APPLICATION No. H16 / 0906 / 93

Listed Building Consent

Description: Conversion into 16 self-contained flats

Location : Longs Warehouse Double Street
Spalding Lincs

12275:59

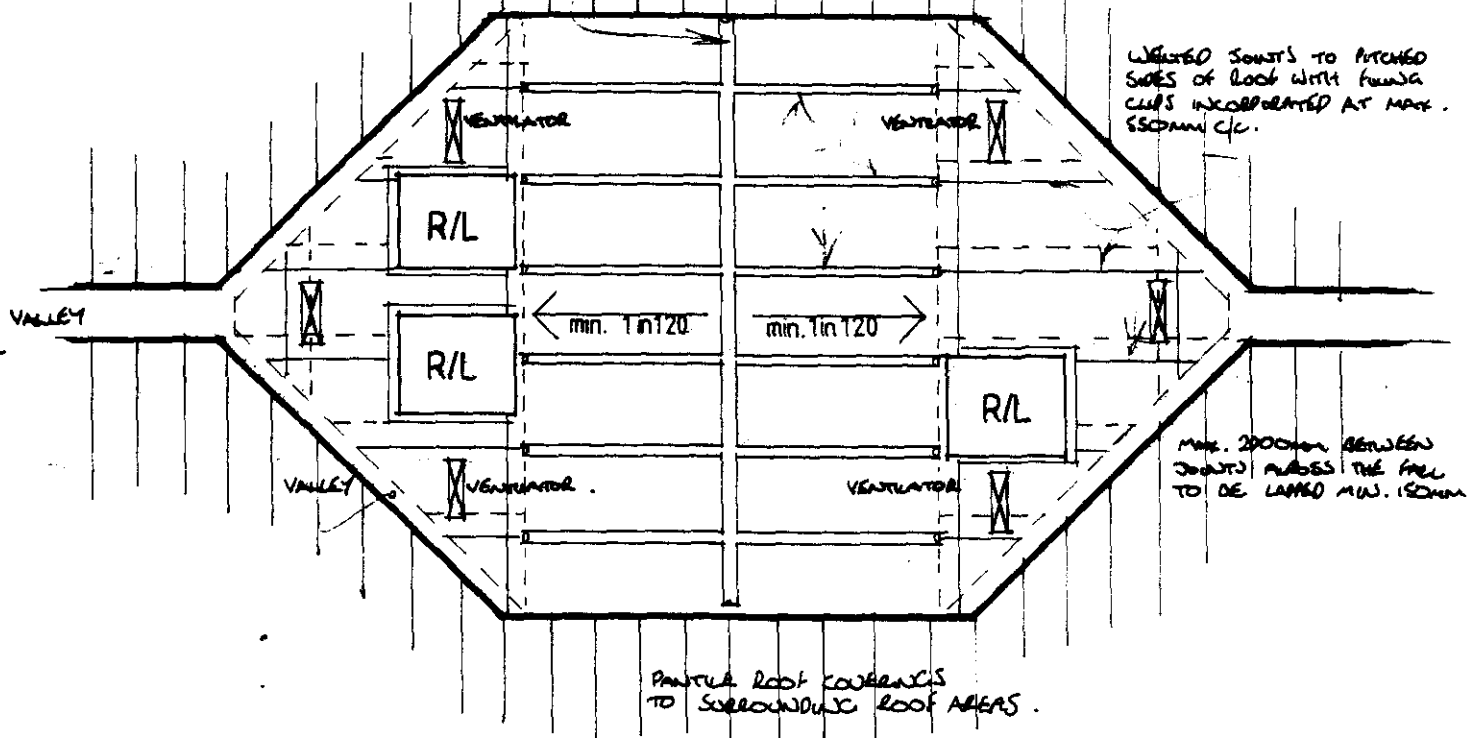
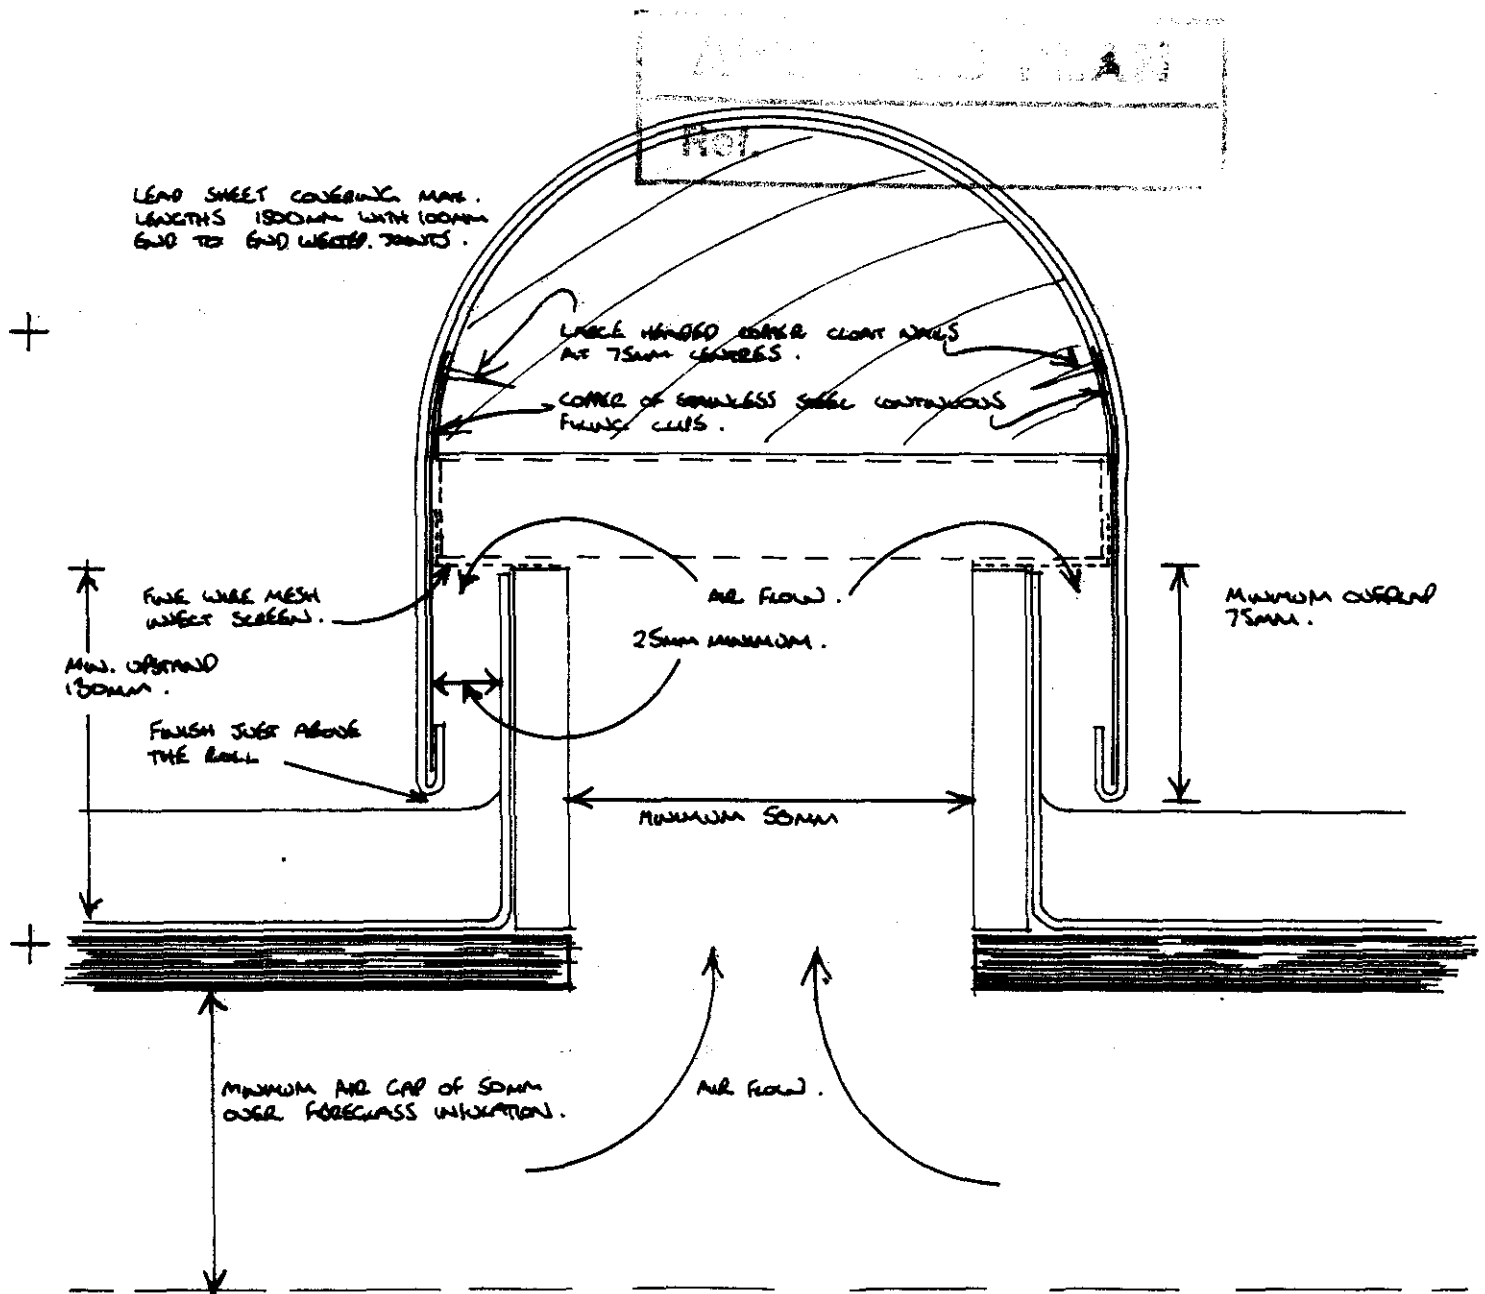
Further to your letter dated 28 September 1993 and the writers meeting with Mr N Midlen earlier this week, we write to confirm that following discussions with our clients we wish to accept your offer of deleting from the proposals the staircases to the rear of Nos 45 and 48 and the roof link to enable Planning Permission to be granted for the rest of the changes.

- LB ?
- 1) Revised roof link - 2 copies of drawing Nos 12275/57A - roof plan/section, 59 - leadwork plan, LDA 20 - lead ventilators, 60 - detail of lead roll ridge vent.
 - 2) Longs roof dormers - 12275/58. ? LB ?
 - X 3) Elevations indicating rear elevations to Nos 45 and 48 (with staircases) deleted, 12275/12G.
Revised floor plans to Nos 45 - 12275/22D.
Revised floor plans to Nos 48 - 12275/23D.

PLEASE FIND ATTACHED DETAILS OF REVISED ROOF
 LINK FOR YOUR URGENT COMMENT TO ENABLE US
 TO INCLUDE ROOF LINK DETAILS IF NECESSARY IN OUR
 REVISED LISTED BUILDING CONSENT APPLICATION.

THE LINK IS NOW ALONG THE LINES PREVIOUSLY
 APPROVED IN THE ORIGINAL LISTED BUILDING &
 PLANNING CONSENTS & WE WOULD APPRECIATE YOUR
 COMMENTS AS TO WHETHER THE ATTACHED DETAILS
 WOULD BE ACCEPTABLE UNDER THE ORIGINAL CONSENTS

The detail submitted of the Longs Warehouse
Dormer is acceptable and the veranda to
the Link wot showing lead to the

No. 12275:60

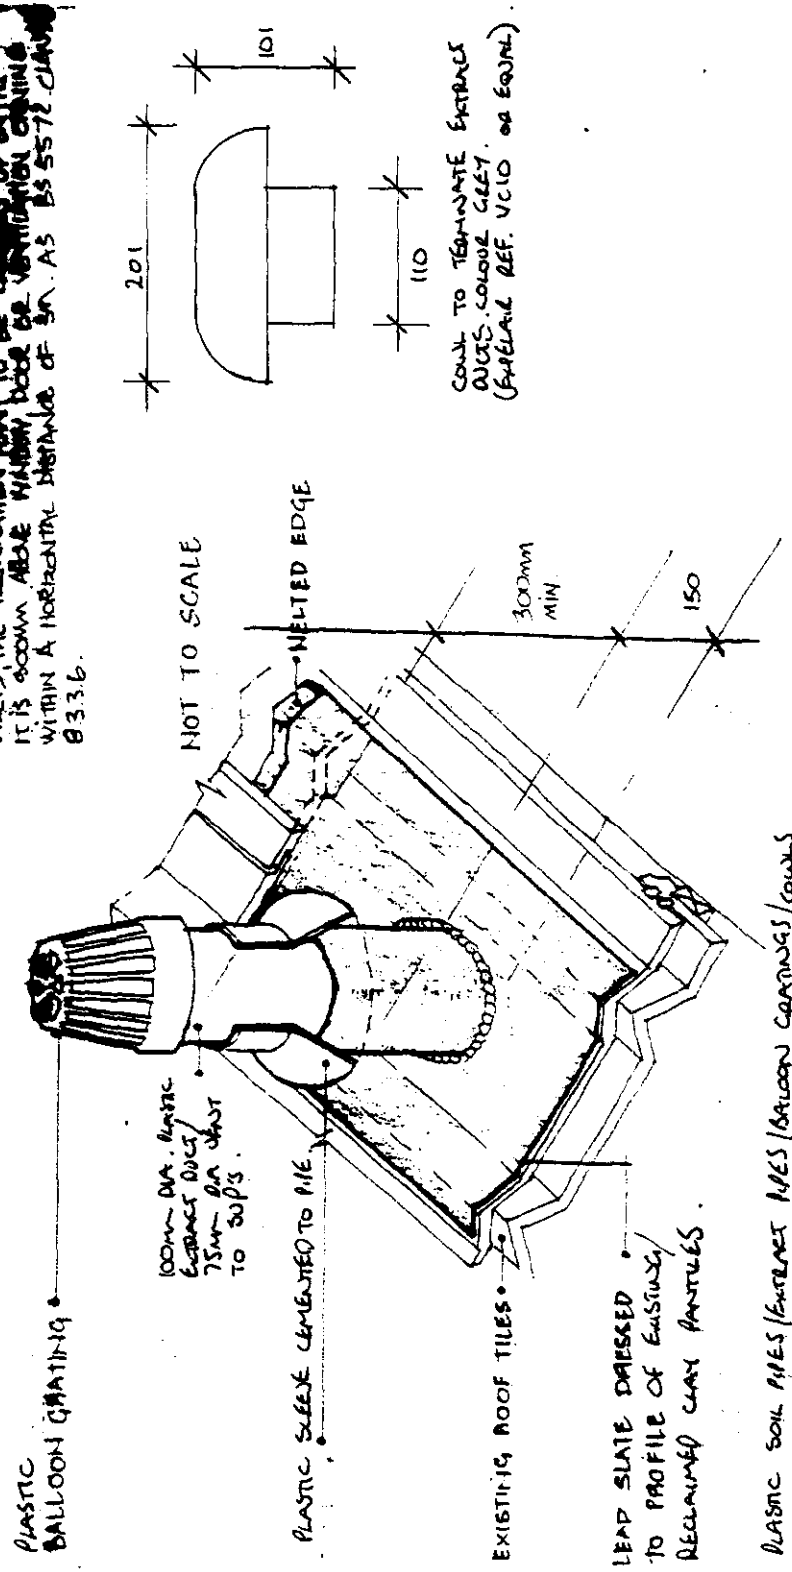
1. The lower bathrooms and the kitchens to flats 3 and 4 are all served by vertical extract ducting to terminate low in the valley slopes of the roofs.
2. The bathrooms and kitchens in the top floor will terminate through the roof on the valley roof slopes above ceiling level.
3. The remaining kitchens will have ducting horizontally through the walls to be terminated with a decorative grating, the positions as indicated on the elevation drawing.

Sheet: 12275.12

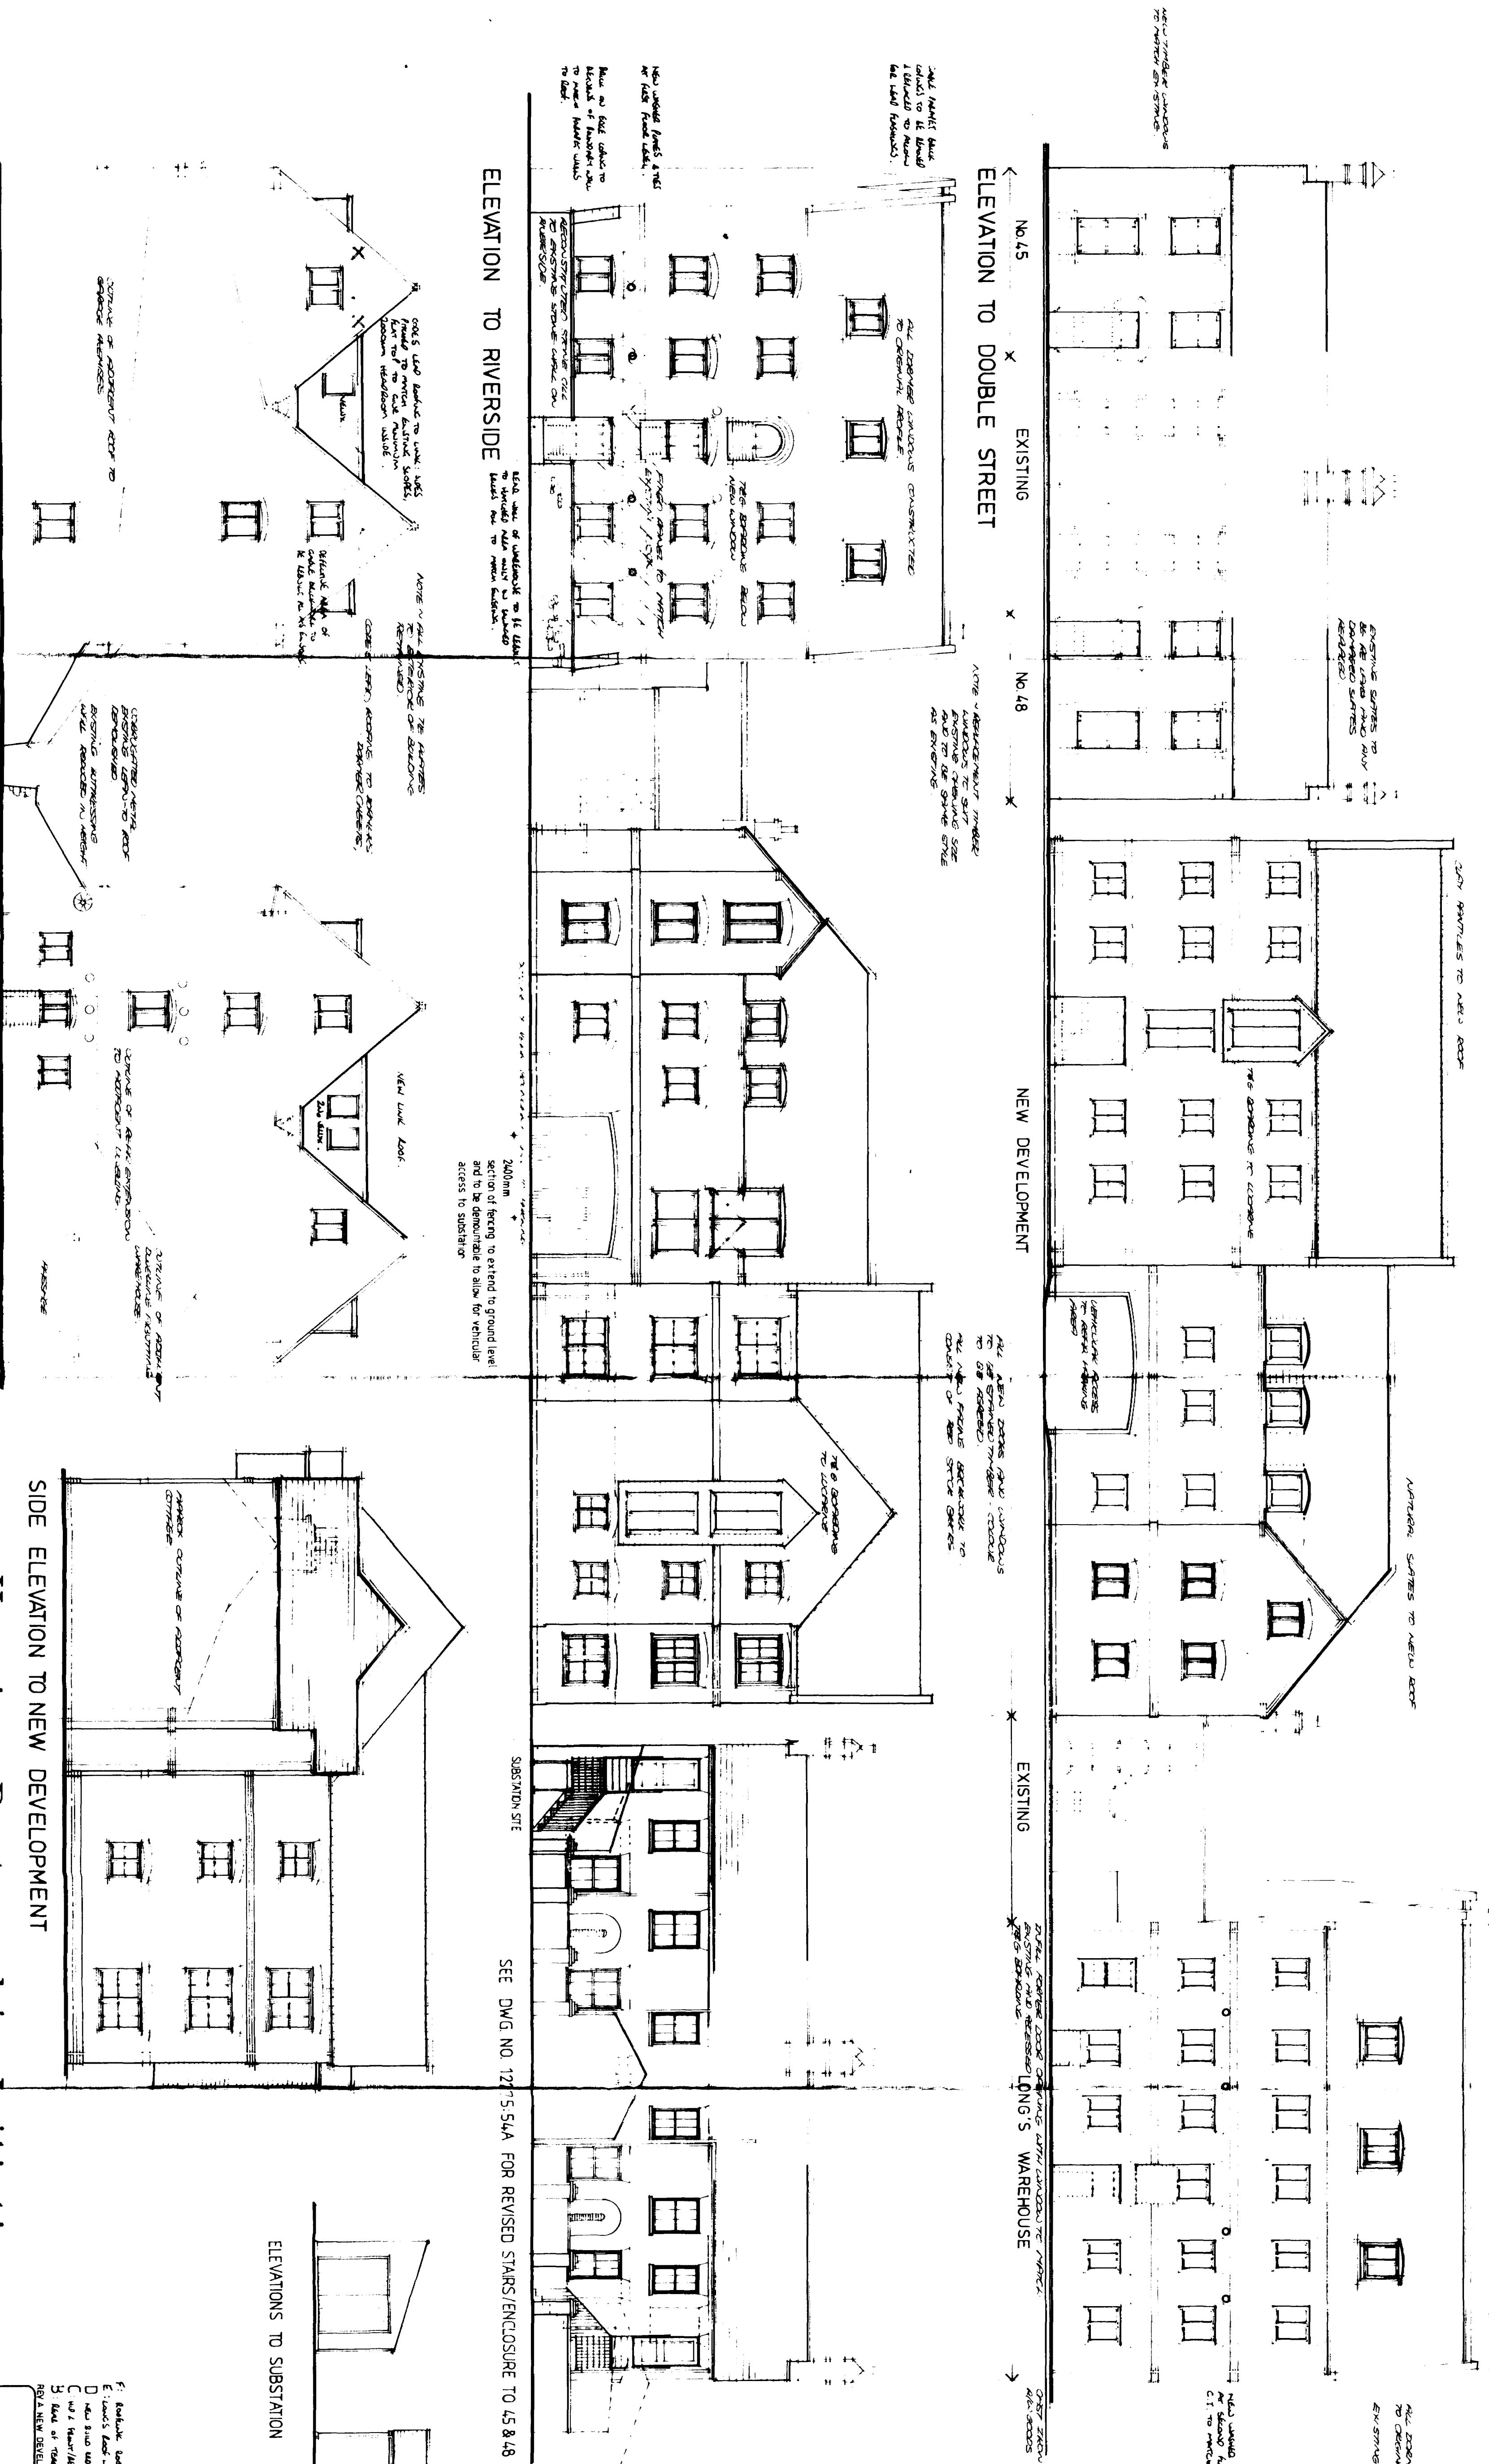
We would also like to confirm that the extent of re-building of the rear wall and gable wall as indicated on the elevations drawing.
